Attachment A

DEER2024 Update

Figure 2-1. Deemed and Evaluated Electric and Gas Savings for Downstream (Rebate) Delivery of SWHC39-04 Smart Thermostat

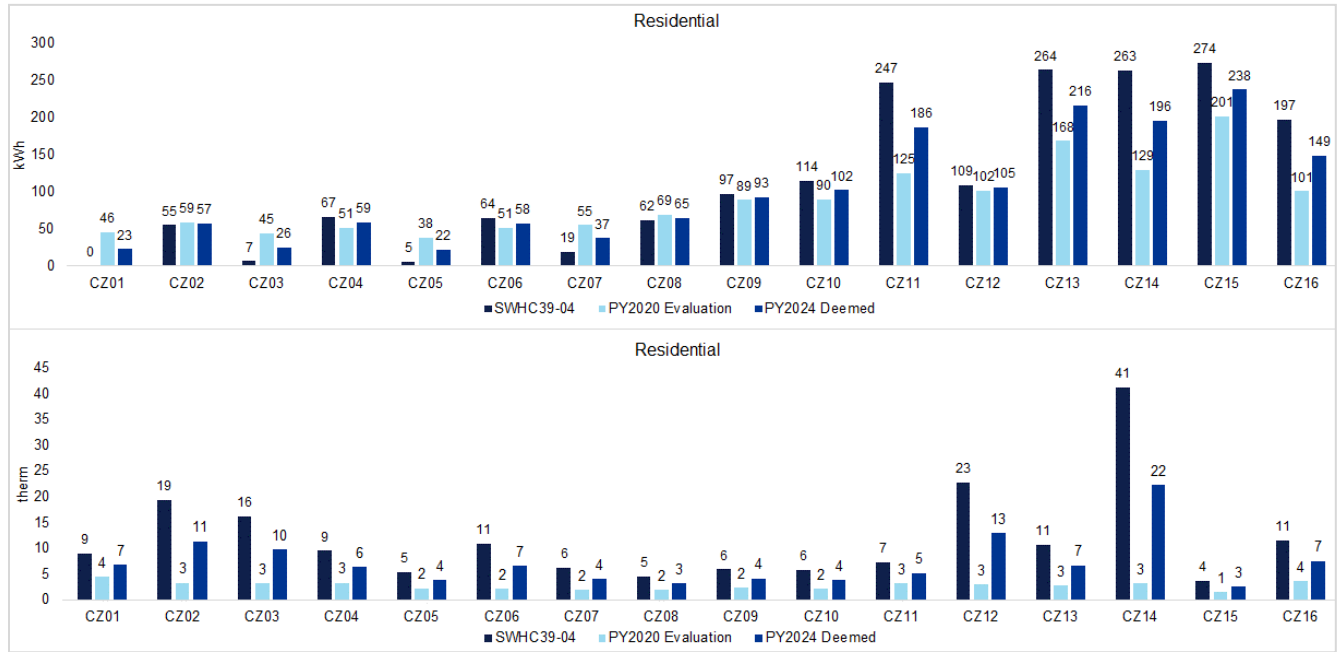
- SWHC39-04 values - 2018 and 2019 evaluation results adjusted to include TO. These values were not affected by residential occupancy due to COVID. A TO adjustment was made to the existing values (see Figure 2-1, Figure 2-2, and Figure 2-3 in black).
- 2020 evaluation results—which included TO as part of the delivered measure—but were likely reduced compared to a typical year due to COVID (see Figure 2-1, Figure 2-2, and Figure 2-3 in light blue).

These are both valid estimates of SCT savings with extremes of no-COVID and all-COVID periods. From an ex ante perspective, it is reasonable to believe that, in the future, we will fall somewhere between these two states, as occupancy rates are unlikely to return to pre-COVID levels. The approach that makes the most sense would be to take the midpoint between the black and light blue bars shown in navy blue in Figure 2-1, Figure 2-2, and Figure 2-3. The UES values shown in these figures are listed in tabular form in Table 2-5, Table 2-6, and Table 2-7.

Table 2-5. DEER2024 Deemed Savings for Downstream (Rebate) Delivery of SCT

Climate Zone	Annual Electric Savings, kWh	Annual Gas Savings, therm
CZ01	22.9	6.74
CZ02	57.2	11.30
CZ03	25.6	9.72
CZ04	59.0	6.38
CZ05	21.6	3.74
CZ06	57.8	6.53
